Sicherheitsmitteilung  
SM 202102

## VECTOR 3SE RESERVE PIN COVER FIELD MODIFICATION

## **VECTOR SE (STUDENT) RESERVE ISSUE**

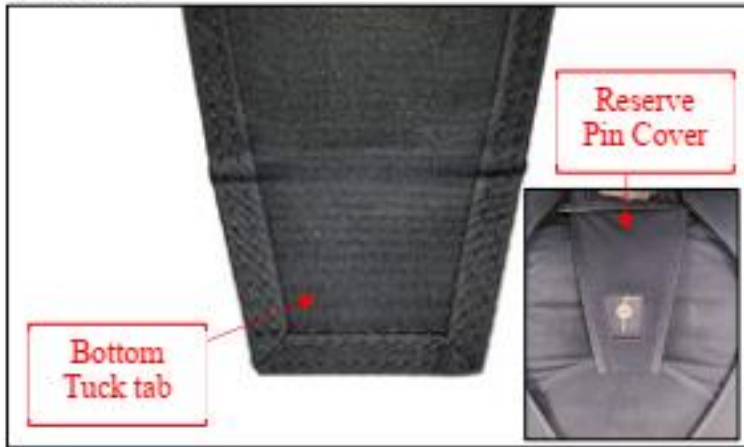
Modification of the bottom tuck tab of the Vector 3 SE Reserve Pin Cover for container sizes V360-1, V360-2, V360-3, V361, V364 and V364-1 built between May 2013 and January 2021.

The Bottom tuck tab is trimmed back 3/8" (9mm)

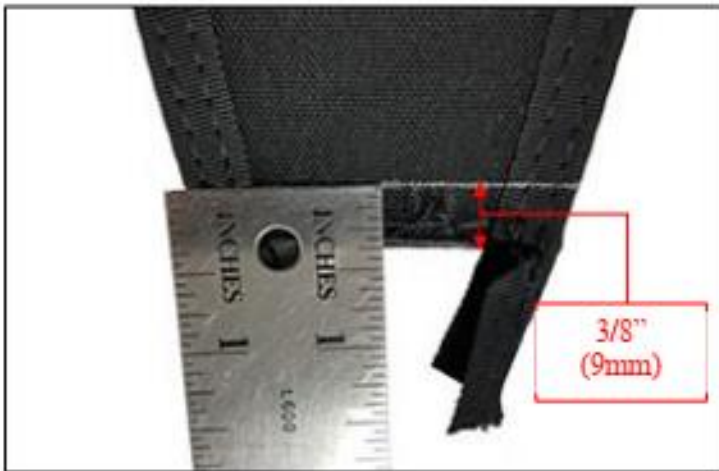
Identify the Reserve Pin Cover flap bottom "Tuck Tab".

Using either snips or a seam ripper, carefully unpick the binding tape stitching from the bottom edge of the flap.

Remove all stitching up to the folded corners.

From the bottom edge of the flap, measure 3/8" (9mm) as shown and mark a line across the flap as shown.

Using heavy scissors, carefully cut and remove the end of the tuck tab.

Sear the cut nylon material and binding tape to stop any fraying.

This is done using a hot knife and 45-degree angle to sear the material to the MDS plastic stiffener. Repeat on both sides of the flap.
